December 10, 2009

RE: The 02002888 CDR cable is difficult to remove from the ACM

Figure 1: Latch mechanism

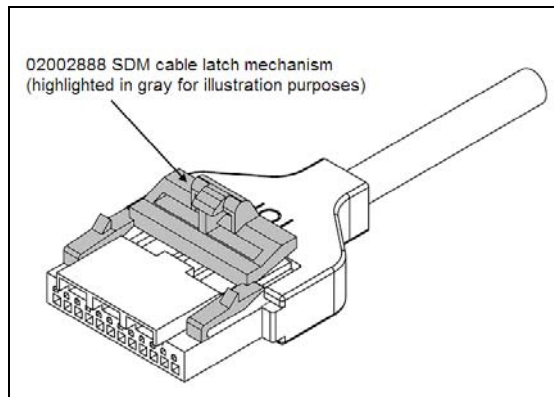
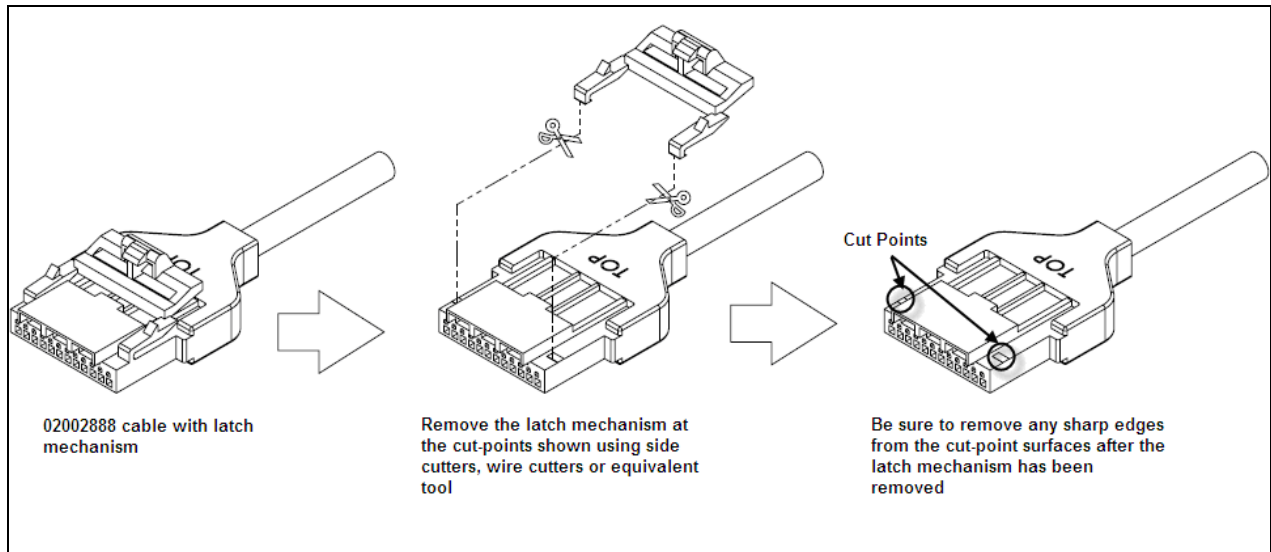
CDR cables with the part number 02002888 purchased prior to December 2009 may be equipped with a latch mechanism on the ACM connector end of the cable (see figure 1 below for illustration). This latch mechanism may make it difficult to remove the connector from the ACM following EDR imaging.

To solve this issue, the latch mechanism on the ACM connector end of the 02002888 CDR cable should be removed in order to avoid potential difficulty removing it from the ACM. Starting December 2009, all 02002888 CDR cables from Bosch will come with the latch mechanism removed from the connector. If your cable still has a latch mechanism affixed to the ACM connector end as shown in Figure 1, follow the instructions below shown in Figure 2 to remove the latch mechanism. Dispose of the latch mechanism once it has been removed from the connector.
